HISTORIC AND DESIGN REVIEW COMMISSION

HDRC CASE NO: 2023-231
ADDRESS: 404 N ALAMO ST
LEGAL DESCRIPTION: NCB 433 BLK: 15 LOT 13 FIRST PRESBYTERIAN SUBD
ZONING: FBZ T6-, HL
CITY COUNCIL DIST.: 1
APPLICANT: Craig Noto/SA Quality Fence & Welding
OWNER: FIRST PRESBYTERIAN CHURCH
TYPE OF WORK: Fence installation
APPLICATION RECEIVED: May 30, 2023
60-DAY REVIEW: July 29, 2023
CASE MANAGER: Rachel Rettaliata
REQUEST:

The applicant is requesting approval to install a 6-foot-tall wrought iron perimeter fence.

DRAFTER: C.C. DATE: 05/23/23 CHECKER: S.S. DATE: 05/23/23	CUSTOMER: FIRST PRESBYTERIAN CHURCH PROJECT: TEXAS STYLE 4 RAIL PANEL W/ RINGS ARCH. OR ENGR.:	JOB NO: 23052142 DWG NO: E-1
--	--	---------------------------------

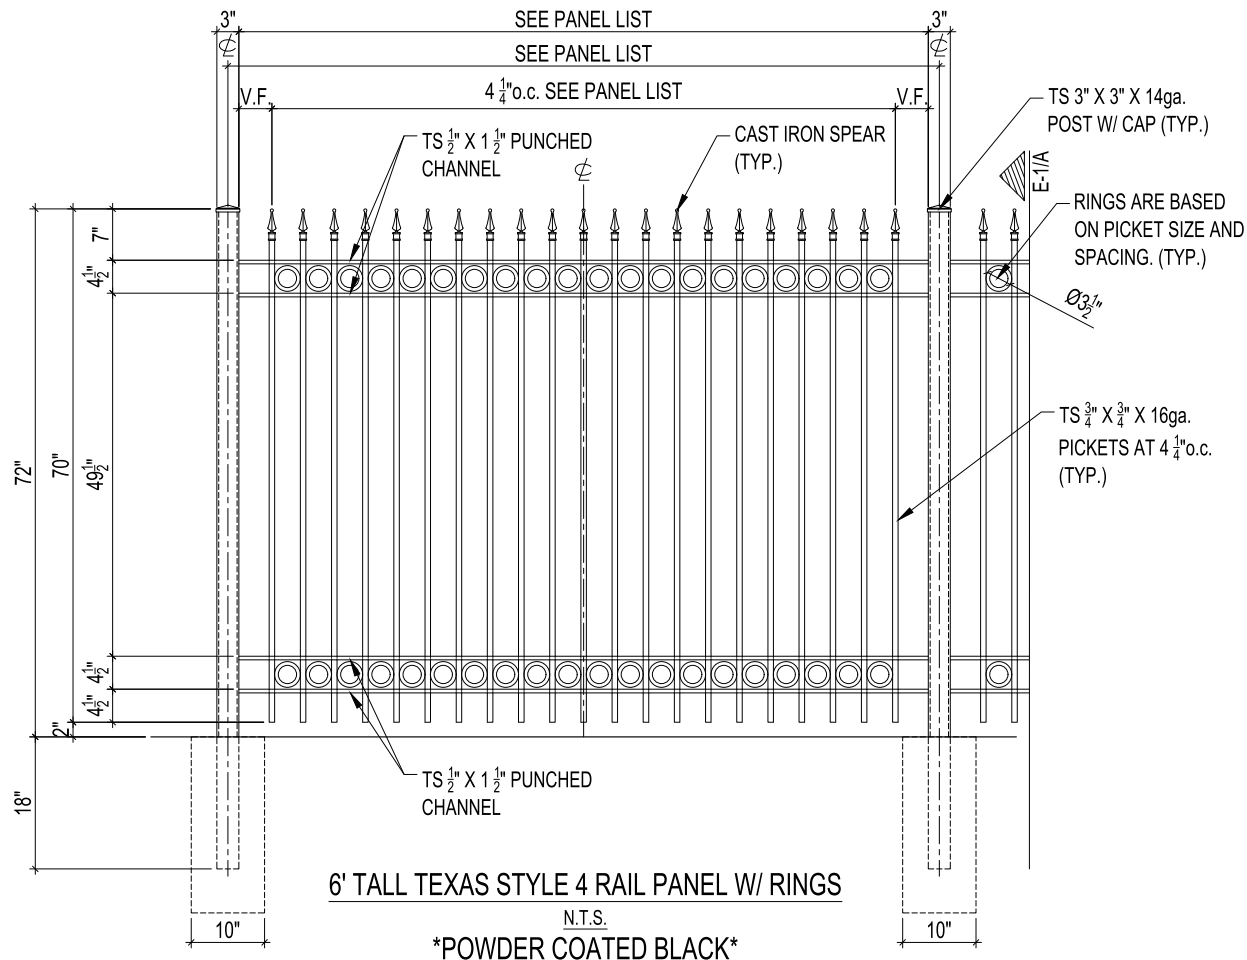
- b. FENCE INSTALLATION (LOCATION) – The applicant has proposed to install a 6-foot-tall wrought iron fencing around the perimeter of the property. The applicant has proposed to install a four-rail panel with rings and cast-iron spears at the north property line along McCullough to the west of the existing garage door, along the front (west) façade at N Alamo, along the south property line at 4th Street, and at the east property line along Avenue E to terminate at the southeast corner of the rear structure. Guideline 2.B.iii for Site Elements states that the appropriateness of a front yard fence is dependent on the conditions within a specific historic district. According to Guideline 2.B.ii for Site Elements, fence installation should be avoided where one did not historically exist, particularly within the front yard. Additionally, new fences and walls should appear similar to those used historically within the district in terms of their scale, transparency, and character. The design of the fence should respond to the design and materials of the house or main structure. As the property is an individual landmark located in a largely commercial context and the front façade features a setback from the public right-of-way, staff finds the fencing location generally appropriate.

- c. FENCE INSTALLATION (HEIGHT) – The applicant has proposed to install a 6-foot-tall wrought iron fencing around the perimeter of the property. Guideline 2.B.iii for Site Elements states that the height of new fences within the front yard should be limited to four feet. The appropriateness of a front yard fence is dependent on conditions within a specific historic district. New front yard fences should not be introduced within historic districts that have not historically had them. If a taller fence or wall existed historically, additional height may be considered. The height of a new retaining wall should not exceed the height of the slope it retains. Guideline 2.C.i for Site Elements states that privacy fences should be set back from the front façade of the building rather than aligning them with the front façade to reduce their visual prominence. As the property is an individual landmark in a commercial context and is not residential, staff finds that the green space along N Alamo provides a buffer zone between the public right-of-way and the structure. Additionally, an open 6-foot-tall fence will not obscure or detract from the structure or its architectural features due to the scale of the historic structure. Staff finds the height generally appropriate.

Staff recommends approval of the perimeter fence installation based on findings a through e with the following stipulations:
